## BELLHOUSE ROAD, SHIREGREEN PROPOSED ZEBRA CROSSING

# ROAD SAFETY AUDIT STAGE 1 [PRELIMINARY DESIGN]

DEVELOPMENT SERVICES
TRANSPORT, TRAFFIC & PARKING SERVICES – ROAD SAFETY
Safety Audit Ref: TE/16-591/LT1976/ST1

Problems relate to preliminary design GA drawing SD-LT1976-P1

TE/16/LT1976/ST1/01

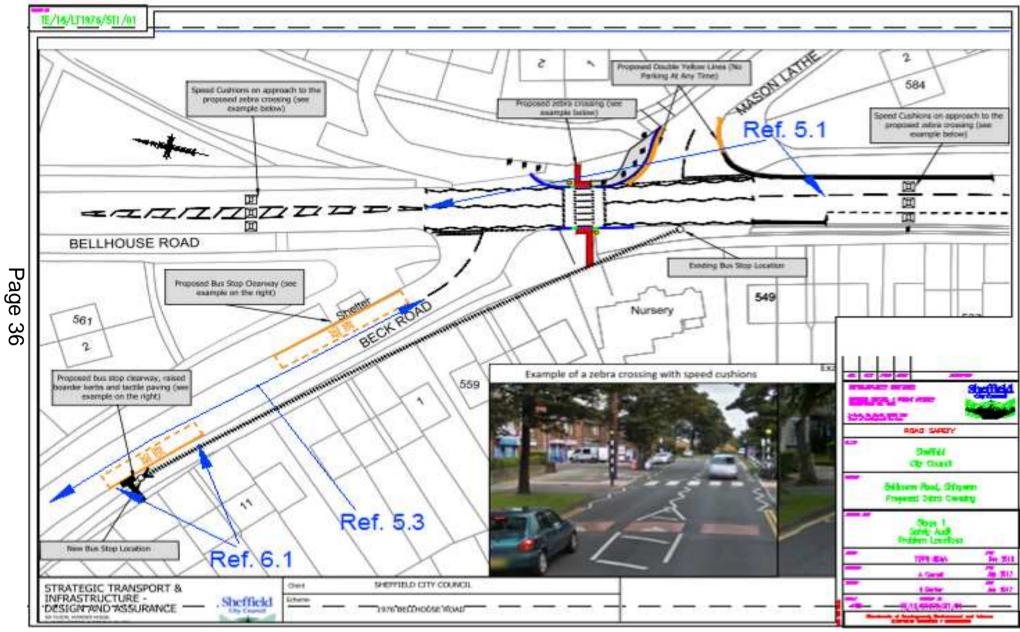
Location: Reference 5.1 on Plan TE/16/LT1976/ST1/01 at Appendix B – Bellhouse Road northbound approach to new crossing; right turn to Mason Lathe Road

Summary: Offset centreline may result in increased risk of pedestrian collisions on crossing, as detailed below

The proposed road marking arrangement includes a 1004 / zigzag centreline along Bellhouse Road, along the approaches to and through the proposed crossing. To the south of the Mason Lathe Road junction, there is a formal on-street parking section on the western side of Bellhouse Road. Along the extents of this parking bay, the centre marking of Bellhouse Road is proposed to be offset to the east of the true centreline of the road, in order to leave equal running lane widths along the parking bay, northbound and southbound.

This offset centreline arrangement has been continued beyond the parking bay northwards, to and through the proposed crossing. The degree of offset past the Mason Lathe Road junction mouth is significant, resulting in a northbound lane width of over 4m.

Northbound drivers approaching the right turn to Mason Lathe Road would be likely to drive to this centre marking, positioning themselves as far to the offside of the running lane as is possible. There would be a likelihood that other northbound through drivers would attempt to pass to the nearside of these right turning vehicles, particularly powered two wheeled vehicles.

In the event that a pedestrian was crossing from east to west, the decelerating / waiting / turning vehicle would block inter-visibility between the crossing pedestrian and the driver of the through vehicle. This would result in an increased likelihood of pedestrian collisions.

Relocate the central zigzag markings along the true centreline of Bellhouse Road on the two crossing approaches, and tie the 1004 marking back across into the offset centreline between the limit of the zigzag, and the northern limit of the parking bay.

The centre line and zig zags were moved following a recommendation from the cycle audit to assist uphill cyclists – it is therefore recommended that the auditors decide which is the preferred lining and the design team will amend accordingly.

The Audit Team stands by its original comments.

A wide carriageway on the northern approach will also encourage faster approach speeds in this direction.

Furthermore, according to the drawing the narrower approach is on the uphill southbound direction. If the centreline were to be offset the usual practice would be to have a wider running lane in the uphill direction to provide more room for motor traffic to overtake a cyclist without squeezing them. The proposals are therefore likely to make the situation worse for cyclists travelling in this direction by making squeezing more likely. The risk of head-on collisions would also be increased in the event of overtaking manoeuvres taking place as northbound drivers are likely to be travelling in a position closer to the eastern edge of the carriageway as well as travelling faster than they do currently, whilst also being masked by the brow of the hill. If the Design Team wishes to implement the recommendations of the Cycle Audit then an Exception Report will be required.

The design will be amended to suit the comments made by the audit team – the revision will be shown at RSA2 for further comment if necessary.

Accepted.

Location: Reference 5.3 on Plan TE/16/LT1976/ST1/01 at Appendix B – Beck Road over limits of carriageway bus-box markings

Summary: Lack of hazard warning line fails to inform drivers of potential hazard of buses manoeuvring, increasing collision risk

Along to the extents of the proposed opposing bus-box markings on Beck Road, a TSRGD diag. 1005 lane line is currently provided along the centre of the road. In such locations TSM recommends the provision of a diag. 1004 hazard warning line, to alert drivers to the possibility of buses manoeuvring into and out of the stops and vehicles overtaking stationary buses.

Failure to provide such a marking reduces awareness of the potential hazards ahead, adversely affecting safety and increasing collision risk.

Provide a TSRGD diag. 1004 hazard warning line along the extents of the bus-box markings extending northwest of them, over extents which accord with TSM Chapter 5 guidance.

In agreement with the audit team the lining recommended will be added to the design and available at RSA 2 for further comment.

#### Accepted.

Location: Reference 6.1 on Plan TE/16/LT1976/ST1/01 at Appendix B -

Beck Road northwest bound bus-stop

Summary: Significant level difference across verge

It is proposed to relocate the Bellhouse Road northbound bus-stop into Beck Lane, to the above position. The drawing provided shows a strip of guidance paving running straight across the verge and footway, up to the new stop.

During the site visit it was noted there is a significant level difference across the verge in this location, as it falls towards the carriageway from the front of the footway. See photo;

It will not be possible to construct the paved strip as indicated due to the severe gradient. In order to provide passenger access between the footway and bus-stop, significant civils works will be required. There will be a need for the provision of ramps and steps, as a minimum.

There is also ongoing restoration work at the adjacent property. In the location indicated by the arrow in the above photograph, there is a gap in the fence at the front of the property. The property owner may be intending to use this area for driveway access to the property.

The Team will need to consider these issues during detailed design, to ensure that the chosen location is viable. An alternative proposal may be required.

The design team have measured the level difference on the topographical survey and confirm that there is approximately 30cm - 40cm difference from back of footway to the front of the verge. Given the width of the footway/verge is 3.4 metres by raising the front with a bus border kerb to 200mm the fall will be approximately 7-8% or 1 in 20. Further details will be provided at RSA stage 2. If the property owner did decide to apply for an access this could be to one side of the bus stop. The drive would be blocked if a bus were to be stationary at the stop.

This satisfies the concerns of the Audit Team, subject to a review once further details are available at RSA 2.

During the consultation on this scheme an objection was received from No. 2 Beck Road (16<sup>th</sup> March 2017). The reply to the resident in response to the points raised are available for the audit team to comment. The design team would welcome further comments in relation to the points raised by the resident before the response is finalised.

The objector has not raised any new road safety issues that were not considered fully by the Audit Team when visiting the site and subsequently producing this report (i.e. the location of the zebra crossing on Bellhouse Road and the position of the bus stop/speed of traffic on Beck Road). As such, the Audit Team has no comments to add to those already raised in this report.
